SITE PROBLEM REPORT

CUSTOMER Toledo Edison Company	ORIGINATOR F.R.Faist	DATE 11/2/77	DOC. NO. CONT. NO. 13 620-0014	SPR NO. 300
VENDOR Crosby	P.A. NO. 023 090 LS		PART NO./TAGG NO. 28/041/005	GROUP NO.
TITLE (MAX 30 CHARACTERS) Electromatic Relief Valve Modification			PROBLEM CONTACT J. E. Anderson

Subject: TOLEDO EDISON (DAVIS BESSE NO. 1)
HPV-SN ASSEMBLY NO. N54890
ADJUSTMENT OF SOLENOID ADJUSTING BOLT

Subject: Adjustment of Solenoid Adjusting Bolt on Pressurizer
Power Relief Valve RC2A

FIG. 1
ASSEMBLY OF PRESSURMATIC
VALVE STYLE HPV-SN

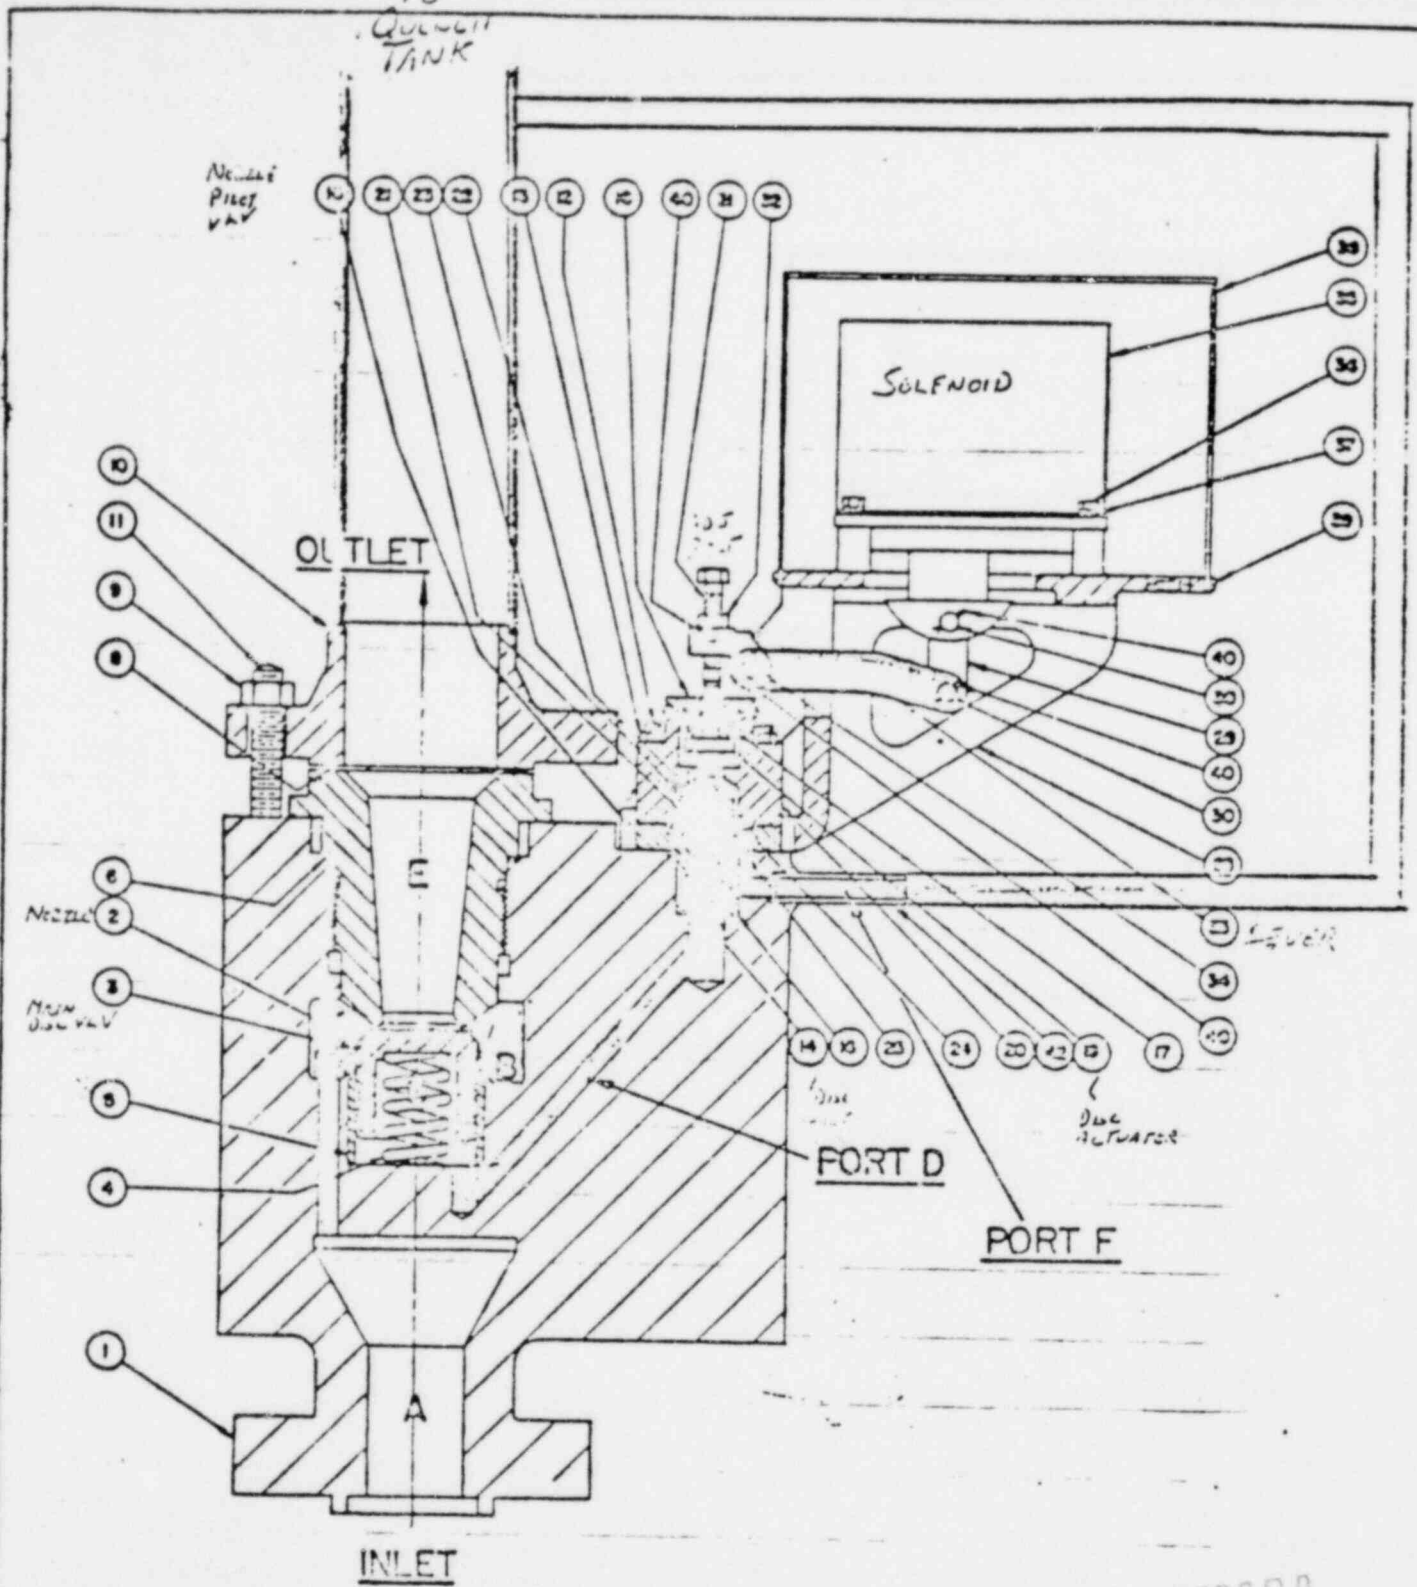
Net Weston measurement is 0.372
Diode measurement is 0.375

Valve was tested at ≈ 1100 psi 10 times and closed satisfactorily with no leakage noted.

Valve was also tested one time at 2150 psi and closed satisfactorily with no leakage noted.

Valve was also opened and closed once and had two additional ≈ 5 second blows ^{at ≈ 1100 psi} the 10 times above
B.P.S.
6/19/77
